## ADDENDUM #1

To: Prospective Bidders  
From: Porter Co. Dept. of Development & Storm Water Management  
Date: November 8, 2024  
Subject: Parker Ditch Headwaters Restoration

This Addendum, designated as Addendum #1, is hereby included in and made a part of the bidding documents, whether or not attached thereto. Except as modified by this Addendum, all requirements of the bidding documents shall remain in full force and effect.

TYPICAL ROCK CHUTE

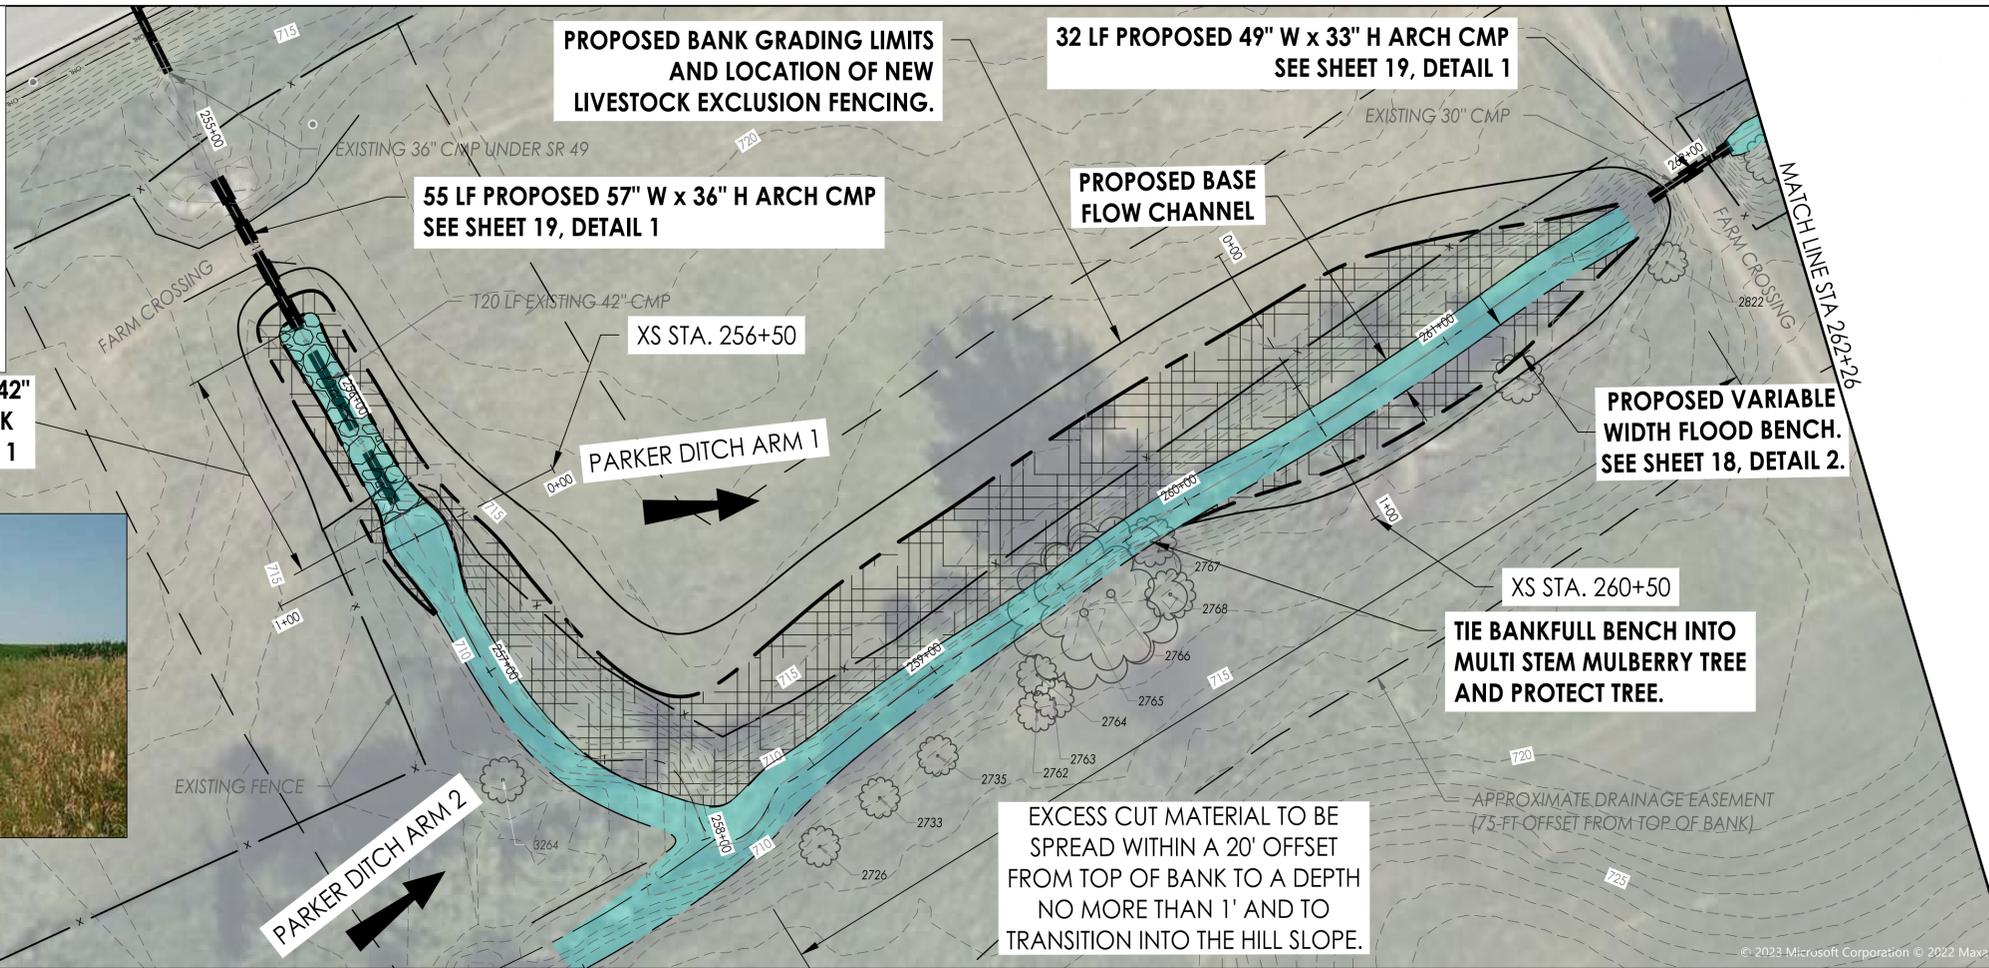
11. Q: The Rock Chute detail on sheet 18 has a discrepancy. The profile view says revetment riprap but the cross section says class 1 riprap. I'm assuming you want revetment, but please confirm.

**DAYLIGHT 62 LF OF EXISTING 42" CMP AND CONSTRUCT ROCK CHUTE. SEE SHEET 18, DETAIL 1**

**A: The callout on the rock chute cross-section has been updated to show that the proposed material is INDOT revetment riprap.**
